PROJECT: TTU TRACK AND FIELD
SBC# 364/011-05-2025
BAA Project Number 25007
Cookeville, Putnam County, Tennessee

SUBJECT: Addendum No 1

OVERALL EXTERIOR
ELEVATIONS

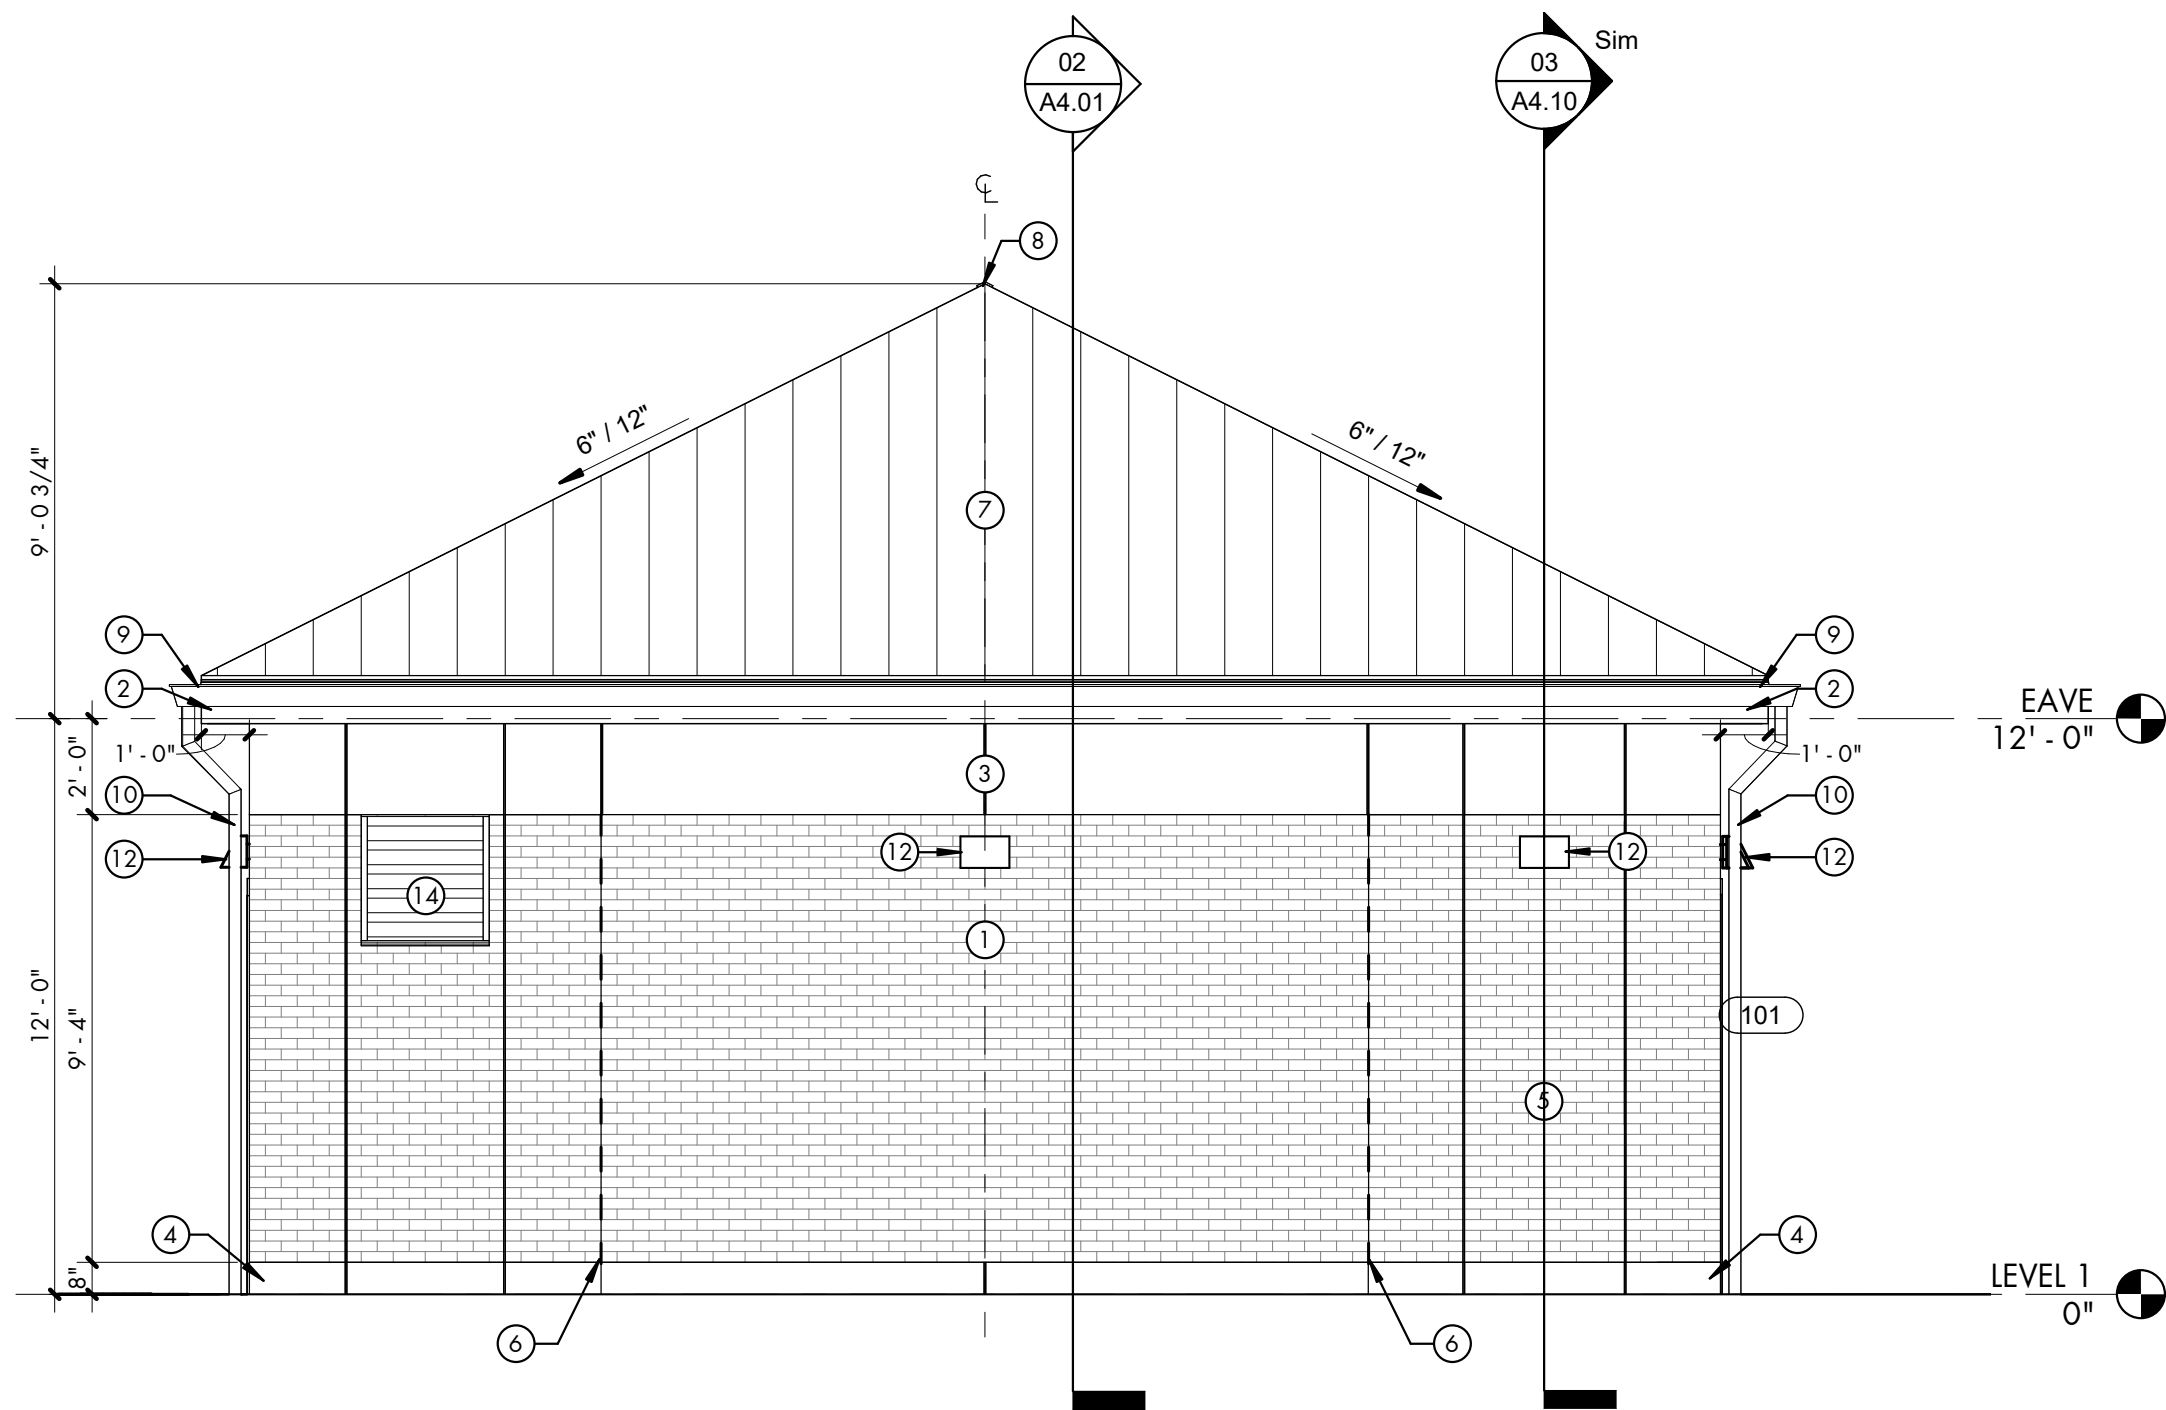
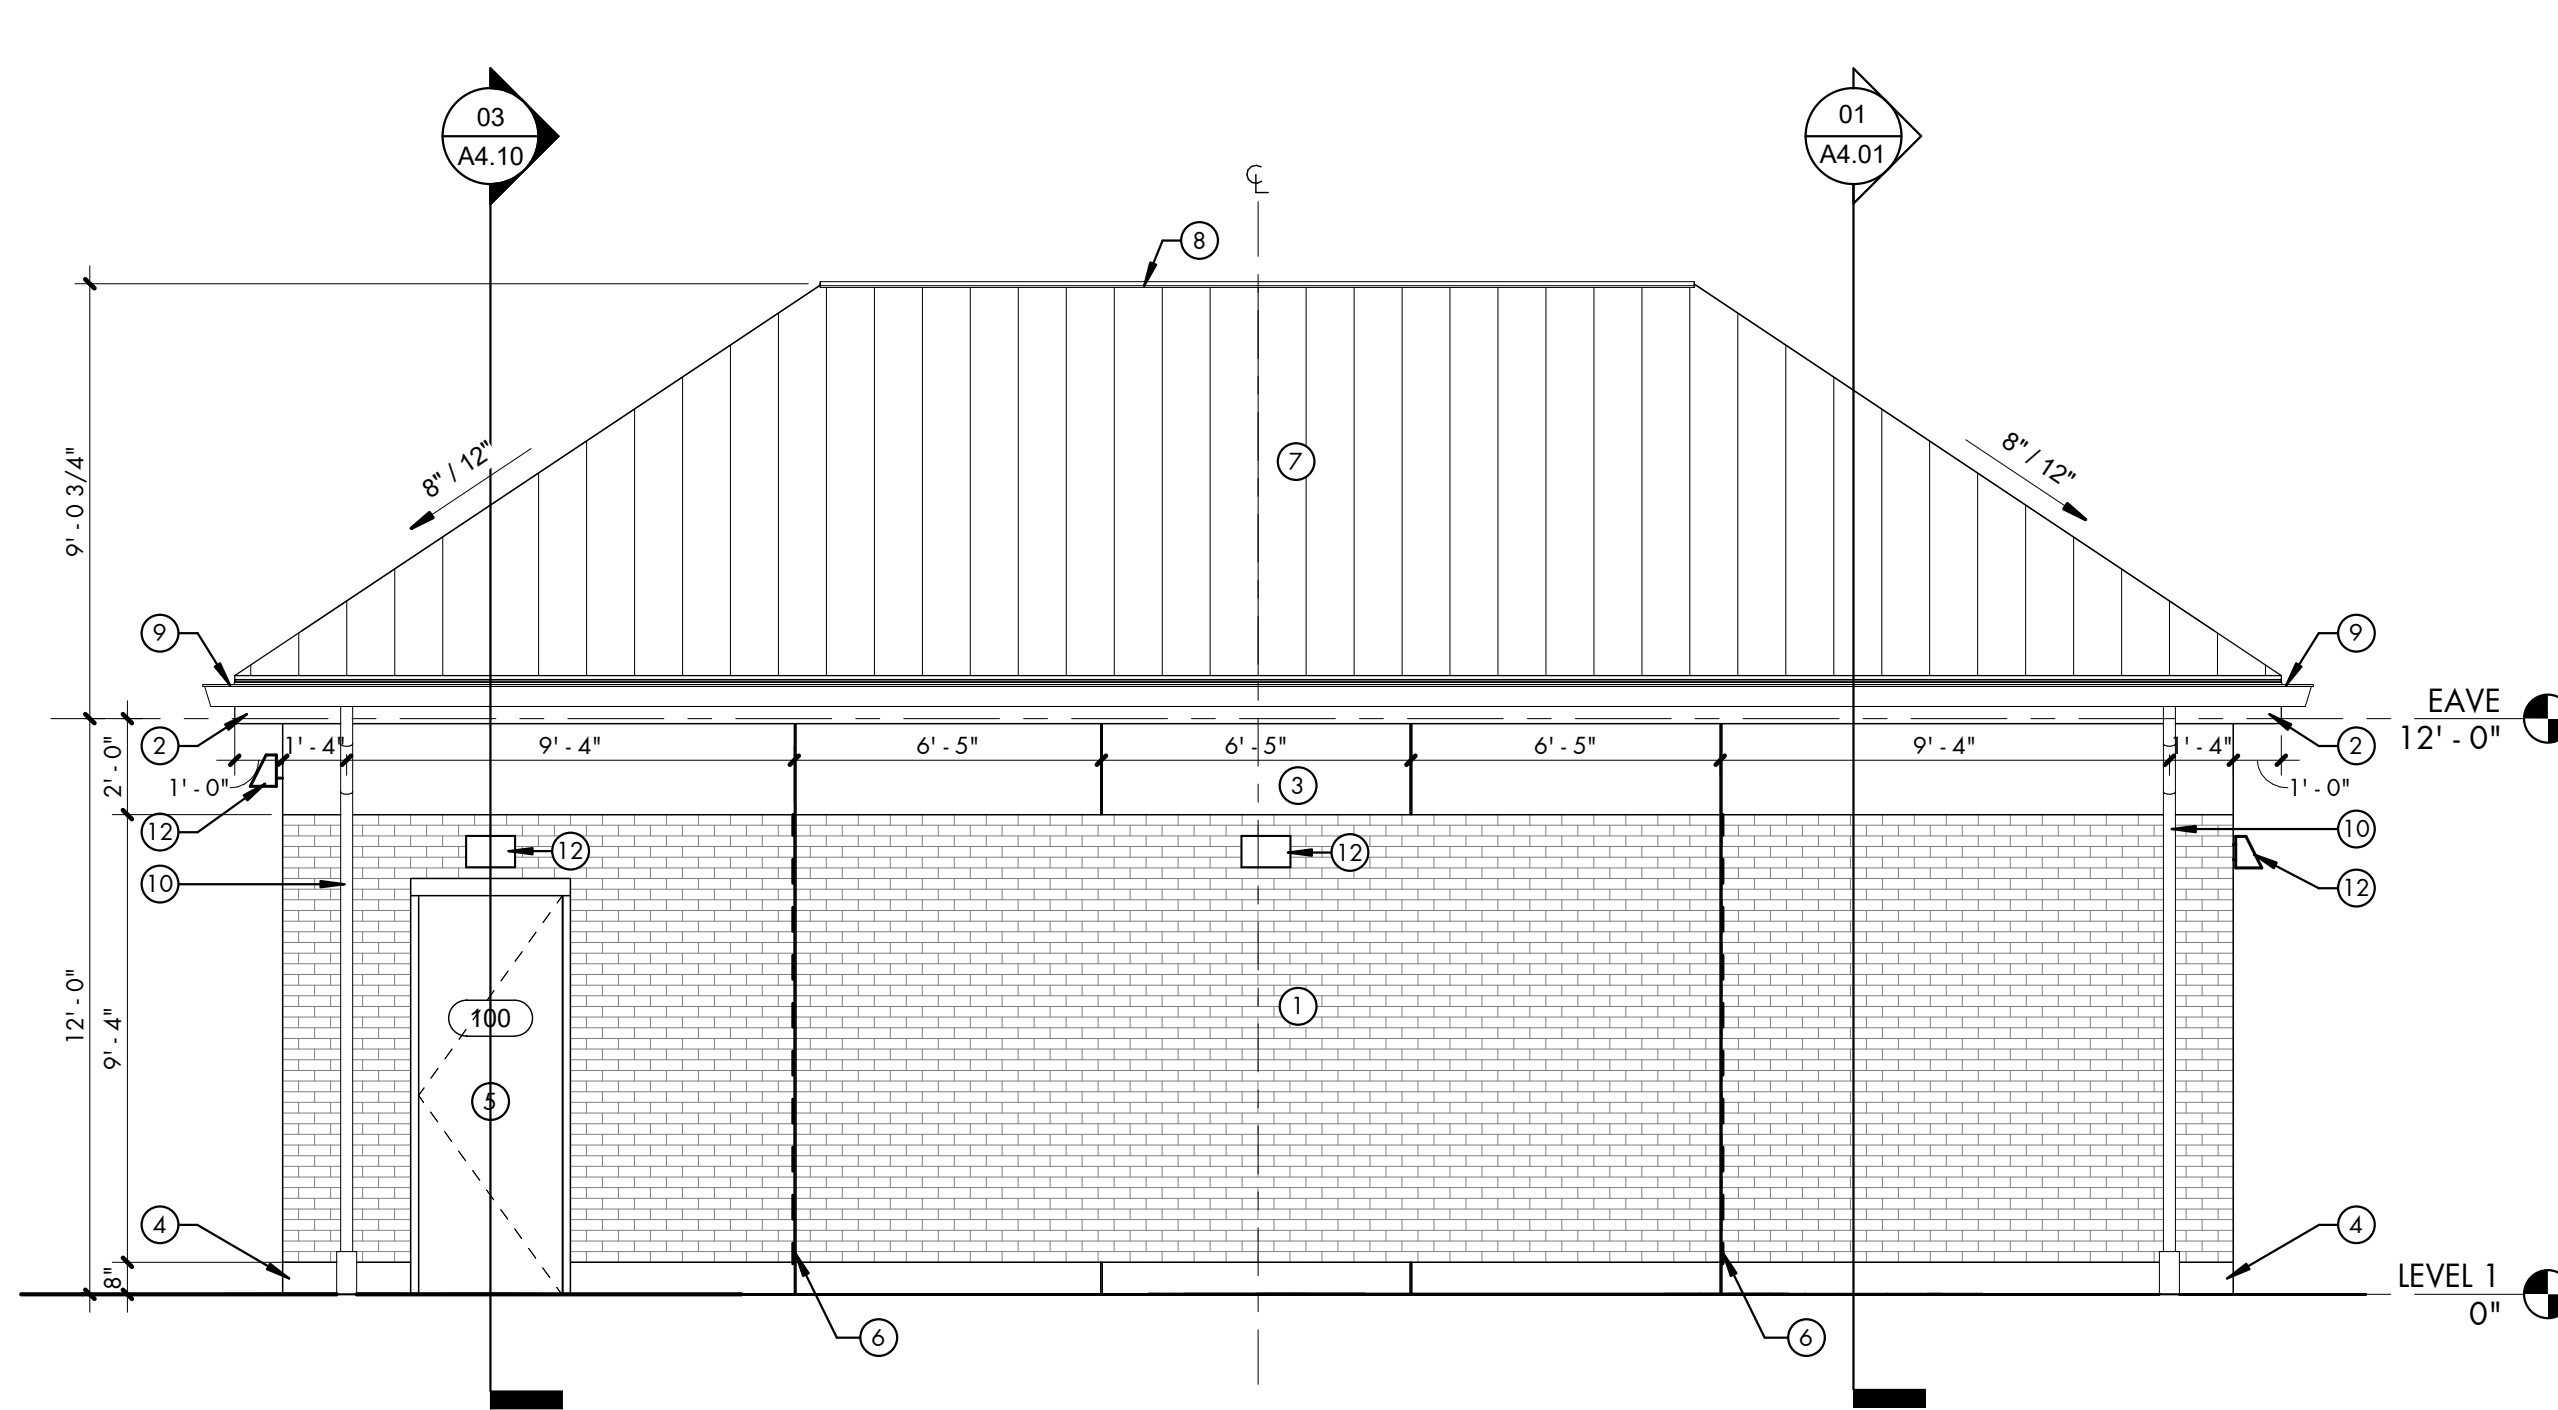
Answer: The building shall match the ACME Engineering Building. The brick specified for ACME was Meridian Brick Company, full range, sand face, face set ACME M/S Windsor Park Velour. Refer to the updated coded notes on Sheet A3.00.
